SONI Consultation Paper: Large Demand Customers Grid Code Modification

Consultation Paper

Public Consultation Document: Proposed Grid Code Modification – Large Demand Customers Requirements

Figure CC.14.1.6: Voltage-against-time profile at the connection point for fault condition

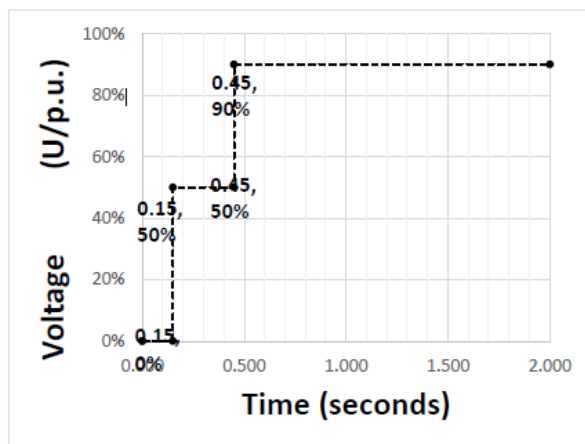
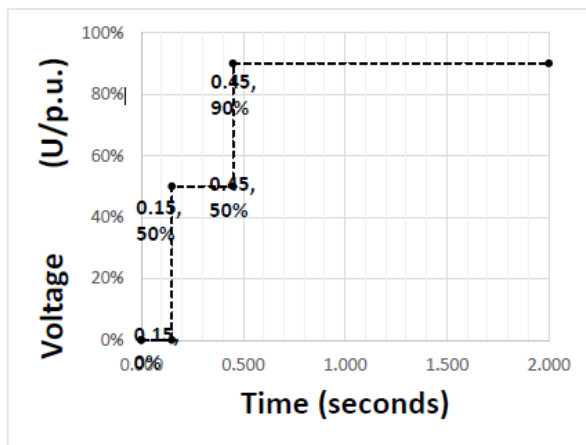
Demand Facilities shall remain connected to the **Transmission System** during rate of change of Transmission System Frequency of values up to and including 1Hz per second as measured over a rolling 500 milliseconds period. (Voltage dips may cause localised RoCoF values in excess of 1 Hz per second for short periods, and in these cases, the Fault-Ride Through clause CC14.1.6 supersedes this clause (CC14.1.5))

Demand Facilities shall remain connected to the **Transmission System** during and following any **Fault Disturbance** on the **Power System** which results in a **Voltage** deviation which remains on or above the voltage-against-time profile specified in Figure CC.14.1.6 at the **Connection Point**. Following clearance of the **Fault Disturbance**, the **Demand Facility** should return to at least 90% of its pre-fault **Active Power Demand** within 500 milliseconds of the **Transmission System Voltage** recovering to 90% of the nominal **Voltage**. The post **Fault Disturbance** ramp up rate for the **Demand Facility**, shall be coordinated and agreed between the **TSO** and the **Demand Facility** owner. The voltage-against-time profile specifies the required minimum capability as a function of voltage and **Fault Ride-Through Time** at the **Connection Point** before, during and after the **Fault Disturbance**.

Demand Facilities shall remain connected to the **Transmission System** during rate of change of Transmission System Frequency of values up to and including 1Hz per second as measured over a rolling 500 milliseconds period. (Voltage dips may cause localised RoCoF values in excess of 1 Hz per second for short periods, and in these cases, the Fault-Ride Through clause CC14.1.6 supersedes this clause (CC14.1.5))

Demand Facilities shall remain connected to the **Transmission System** during and following any **Fault Disturbance** on the **Power System** which results in a **Voltage** deviation which remains on or above the voltage-against-time profile specified in Figure CC.14.1.6 at the **Connection Point**. Following clearance of the **Fault Disturbance**, the **Demand Facility** should return to at least 90% of its pre-fault **Active Power Demand** within 500 milliseconds of the **Transmission System Voltage** recovering to 90% of the nominal **Voltage**. The post **Fault Disturbance** ramp up rate for the **Demand Facility**, shall be coordinated and agreed between the **TSO** and the **Demand Facility** owner. The voltage-against-time profile specifies the required minimum capability as a function of voltage and **Fault Ride-Through Time** at the **Connection Point** before, during and after the **Fault Disturbance**.
